**Subject:** [External\_Sender] Why does the NRC conduct unscientific reviews of the public's rulemaking petitions, NRC Chairman Burns? (NRC-2009-0554)

In this e-mail, I discuss the NRC's review of a petition for rulemaking that I submitted in 2009 (PRM-50-93). I allege that the Staff's review of PRM-50-93 has been biased and unscientific. Please note that I provide evidence below in Section I.

**Figure 1. Section of the FLECHT Run 9573 Test Bundle that Incurred Runaway Oxidation**

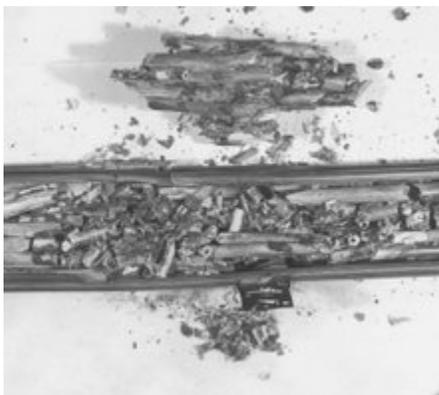
As part of their technical analysis of PRM-50-93, the NRC did a computer simulation of what occurred when the FLECHT Run 9573 test bundle incurred runaway oxidation (or thermal runaway) (see Figure 1). They wanted to compare the results of their simulation to the data that Westinghouse reported. However, there was a big problem with the NRC's simulation. They did **not** simulate the section of the test bundle that incurred runaway oxidation.[2] (Or if they did simulate that section, they decided not to release their findings.)

By way of an analogy: what the NRC did would be like simulating a forest fire and omitting trees reduced to ash and only simulating those that had been singed. After doing such a bogus simulation one might try to argue that trees actually do not burn down in forest fires. The NRC did something similar. They used the results of their simulation to argue that the currently used zirconium-steam reaction correlations, such as the Cathcart-Pawel and Baker-Just correlations, are adequate for use in computer safety models like the NRC's TRACE code.[3]

In November 2015, after I made a series of additional complaints, the NRC finally disclosed the results of a computer simulation of FLECHT Run 9573 that included the section of the test bundle that incurred runaway oxidation. And the simulation *under*-predicted temperatures Westinghouse had reported for that section. [11] This is powerful evidence that the currently used zirconium-steam reaction correlations, such as the Cathcart-Pawel and Baker-Just correlations, are **inadequate** for use in computer safety models like the NRC's TRACE code.

The NRC conducted TRACE code computer simulations of FLECHT Run 9573 and found that TRACE *under-predicted* temperatures that were reported by Westinghouse at the 7 ft elevation of the test bundle. On November 24, 2015, Aby Mohseni, Deputy Director of the NRC’s Division of Policy and Rulemaking, sent me an e-mail regarding the NRC’s TRACE computer simulation of FLECHT Run 9573. In his e-mail, Mr. Mohseni disclosed findings of “the completed simulation [for] the cladding and steam temperatures at the 7-ft elevation (at 18 seconds).”[14]

TRACE *under-predicted* cladding and steam temperatures at the 7-foot elevation of the FLECHT Run 9573 test bundle. TRACE is supposed to *over-predict* temperatures in order to ensure an adequate margin of safety. The Baker-Just and Cathcart-Pawel zirconium-steam reaction correlations were used for the TRACE simulations. The TRACE simulations need to be considered as evidence that the NRC and nuclear industry’s computer safety models under-predict the zirconium-steam reaction rates that would occur in the event of a design-basis accident (loss-of-coolant accident).

Taking the time difference of 0.2 seconds (between 18 and 18.2 seconds) into account, when TRACE used the Cathcart-Pawel and Baker-Just correlations, it predicted *cladding* temperatures that were at least 200°F and 140°F lower, respectively, than the temperatures Westinghouse reported. That is *non-conservative*.

When TRACE used the Cathcart-Pawel and Baker-Just correlations, at 18 seconds it predicted *steam* temperatures that were about 500°F and 450°F lower, respectively, than the temperatures Westinghouse measured at 16 seconds. Westinghouse also reported that after 12 seconds, steam temperatures were increasing at a rate greater than 300°F/sec. So steam temperatures were even greater at 18 seconds than they were at 16 seconds. Hence, the TRACE predictions for steam temperatures are *non-conservative*.

Figure 1. Local Cladding Temperature vs. Time in the PHEBUS B9R-2 Test[34]

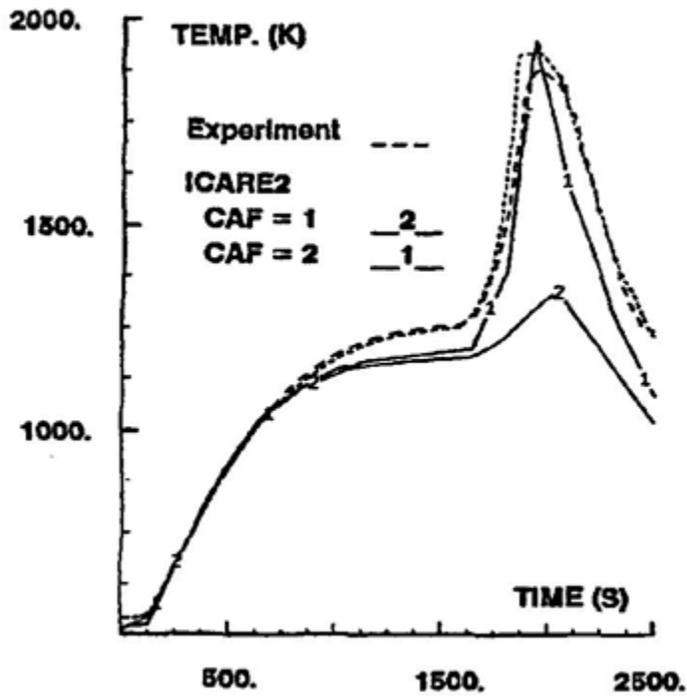
uranium dioxide (UO<sub>2</sub>) fuel rods. The B9R test was conducted in two parts: the B9R-1 test and the B9R-2 test.[31] A 1996 European Commission report states that the B9R-2 test had an unexpected fuel-cladding temperature escalation in the mid-bundle region (see Figure 1); the highest temperature escalation rates were from 20°C/sec (36°F/sec) to 30°C/sec (54°F/sec).[32]

Today, in 2016, oxidation models still cannot accurately predict the local fuel-cladding temperature escalation that commenced in PHEBUS B9R-2 in steam when local fuel-cladding temperatures were 1027°C (1880°F). The PHEBUS B9R-2 results indicate that the currently used zirconium-steam reaction correlations, such as the Baker-Just correlation, are inadequate for use in computer safety models like the TRACE code.
